Reference: 261-277 King Edward Avenue & 260 Murray Street

Transportation Overview – Addendum #1

Our File No. 112078

# APPENDIX A REVISED SITE PLAN

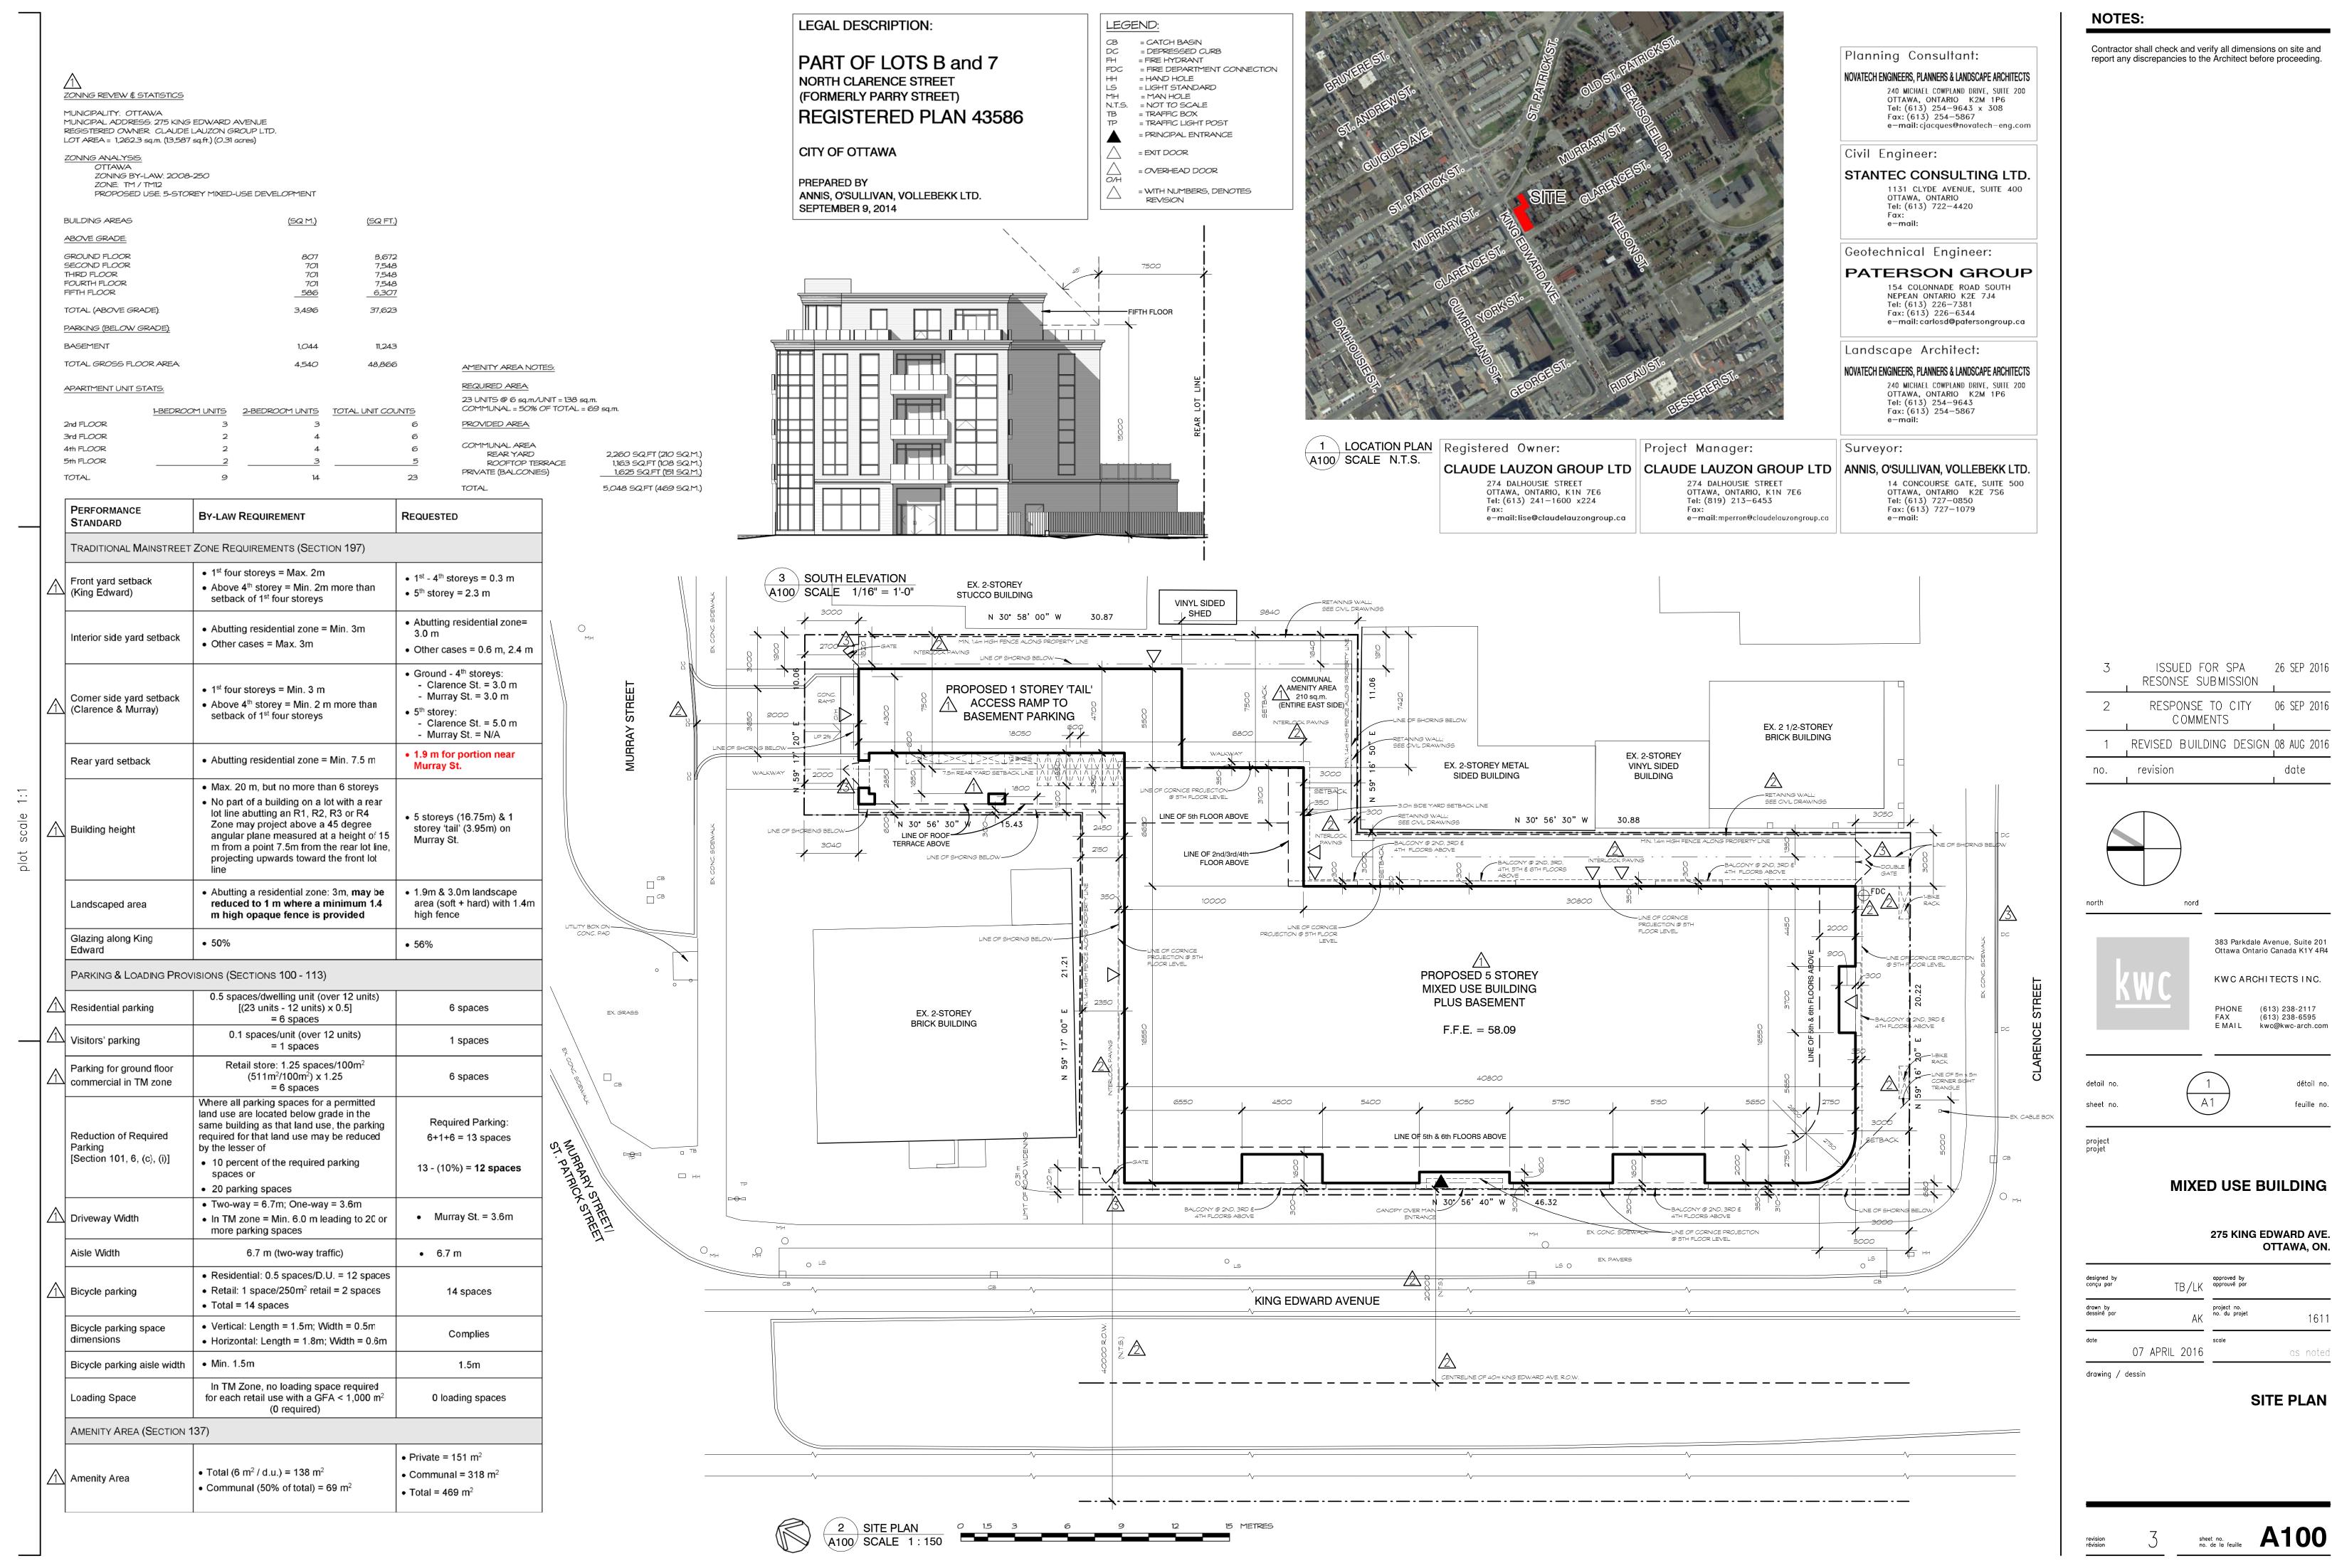
Since the original submission, the site plan has been revised. The revised site plan has reduced the number of apartment units from 31 to 23, and increased the GFA for the retail component from 4,520 s.f. to 5,500 s.f. The revised site plan also removes the underground parking garage on Clarence Street, reduced the width of the Murray Street access to 3.6m, and reduced the number of spaces in the Murray Street parking garage to 19. The number of bicycle parking spaces have also been reduced to 14.

The revised development has removed the parking garage accessed from Clarence Street. The width of the Murray Street access has been reduced to 3.6m at the property line. The City of Ottawa's *Zoning By-law* (ZBL) identifies a maximum width of 3.6m for a double traffic lane that leads to less than 20 parking spaces.

The revised site access is located approximately 3m from the easterly property line and 3.4m from the westerly property line, satisfying the minimum spacing requirements identified in the City of Ottawa's *Private Approach By-law*.

Based on the foregoing table, the ZBL identifies a requirement to provide 14 bicycle parking spaces for the proposed development. As shown on the revised site plan, two bicycle parking spaces are provided along Clarence Street and 12 bicycle parking spaces will be provided in an enclosure adjacent to the Murray Street access.
